Thames Farm Development

FRA and drainage proposal review

FWM8833-RT001-R02-00

July 2021

Figure 4.1: Enzygo flood outline for 20 year and 1000 year model runs

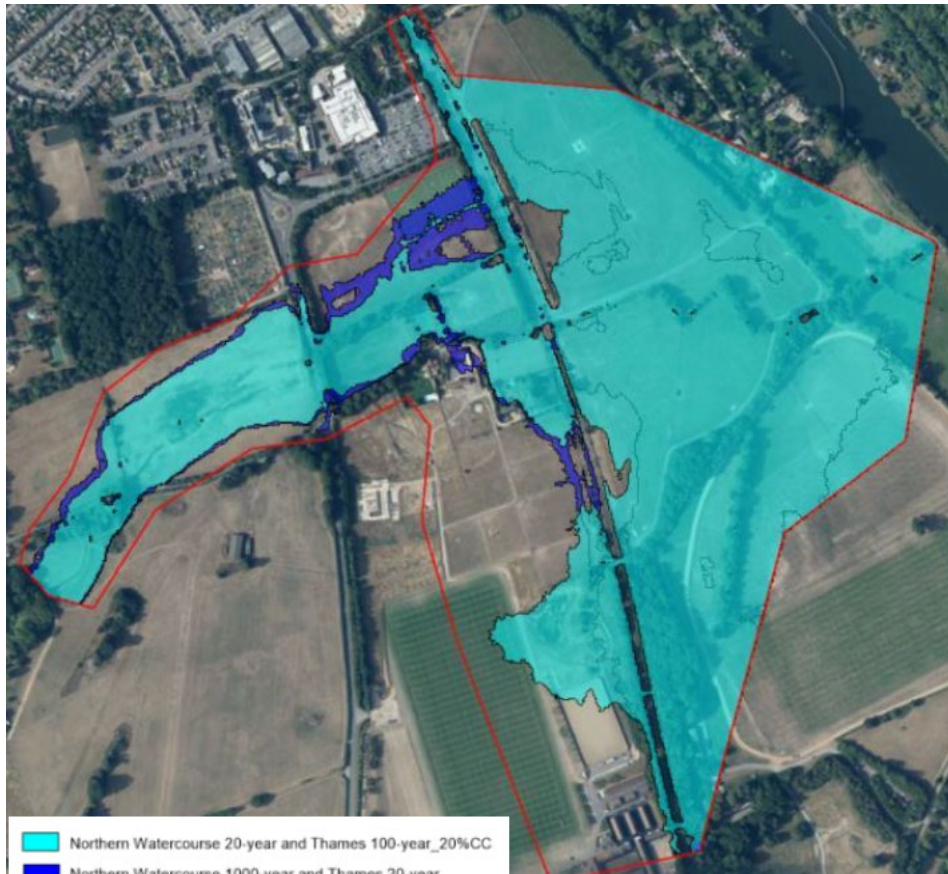
The flood outline indicates (what is believed to be) an incorrect outfall point to the River Thames.

Figure 4.2: Geological voids investigation showing ground characteristics of the site

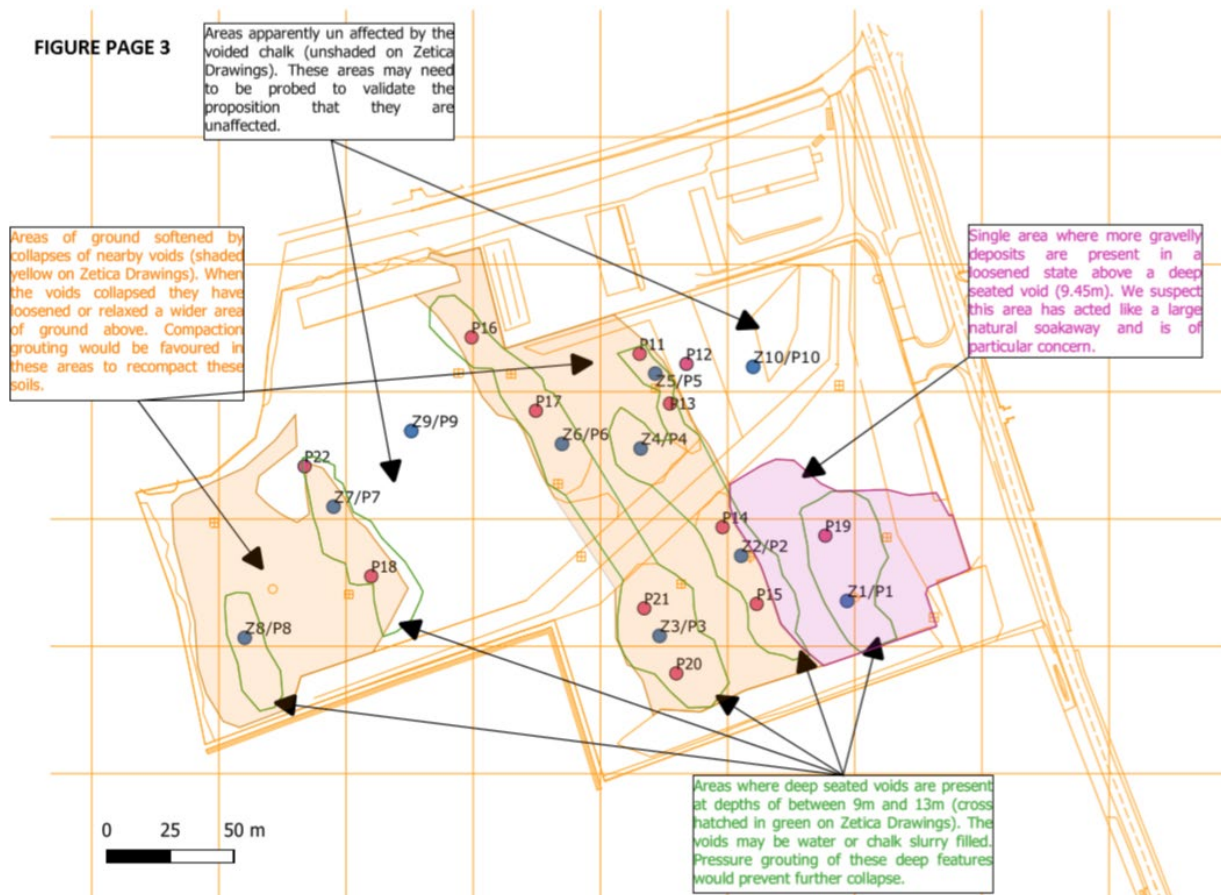
The use of infiltration SuDS is being discounted in spite of the fact that all properties and roads around the area are nearly all based on the use of soakaways. There is a development on the other side of the A4155 which is currently being built with using soakaways.

Although there are implications for voids creation, the speed at which chalk dissolves is such that it is likely that the development drainage could have been planned around this constraint - using soakaway elements at a safe distance from the dwellings. A lower density development, taking into account the geological investigations (see Figure 4.2) may well be possible. Figure 4.2 shows that there are a number of areas of reduced or minimal occurrence of voids (ALP 2020).

20. Outfall to River Thames by Mill Lane.

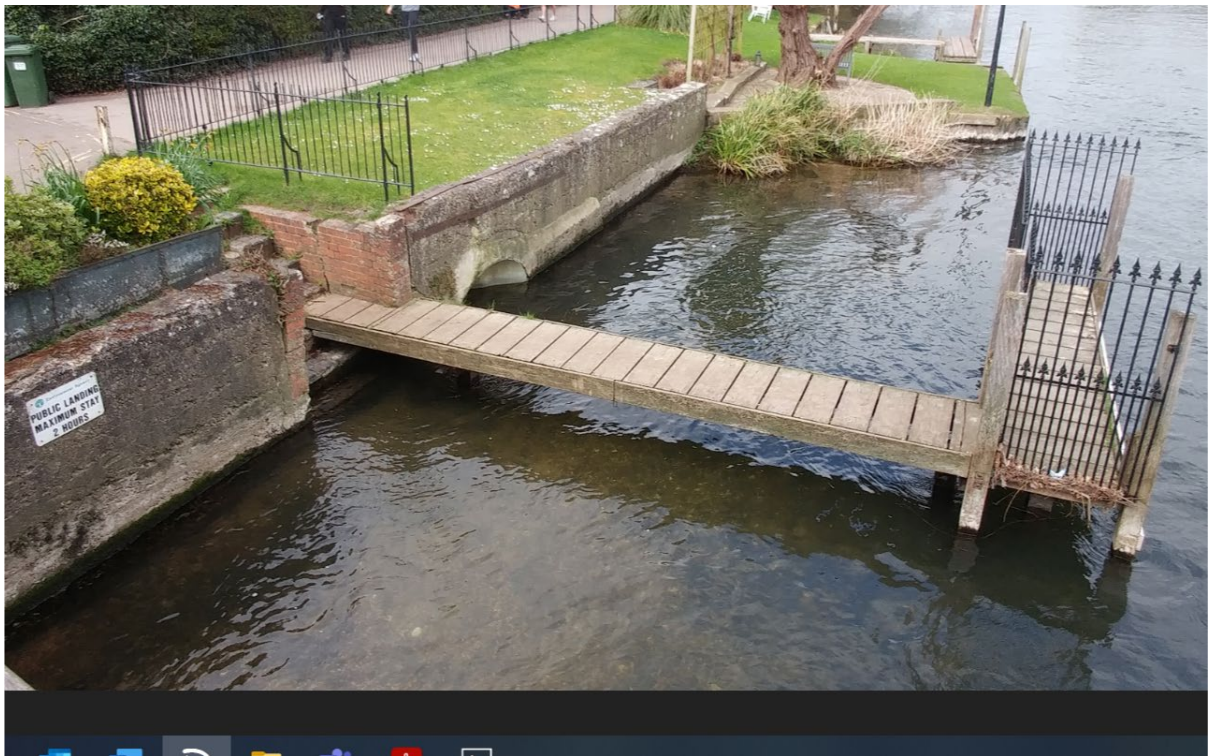
Mill lane also acts as a flow conduit during flooding though flooding often commences as a backwater effect from the R. Thames.

The flood events from the Harp valley and the R. Thames are often in sync due to the delay in runoff from the chalk response. However there is not complete dependency (not least because much of the R. Thames catchment is up to 100 miles to the west).
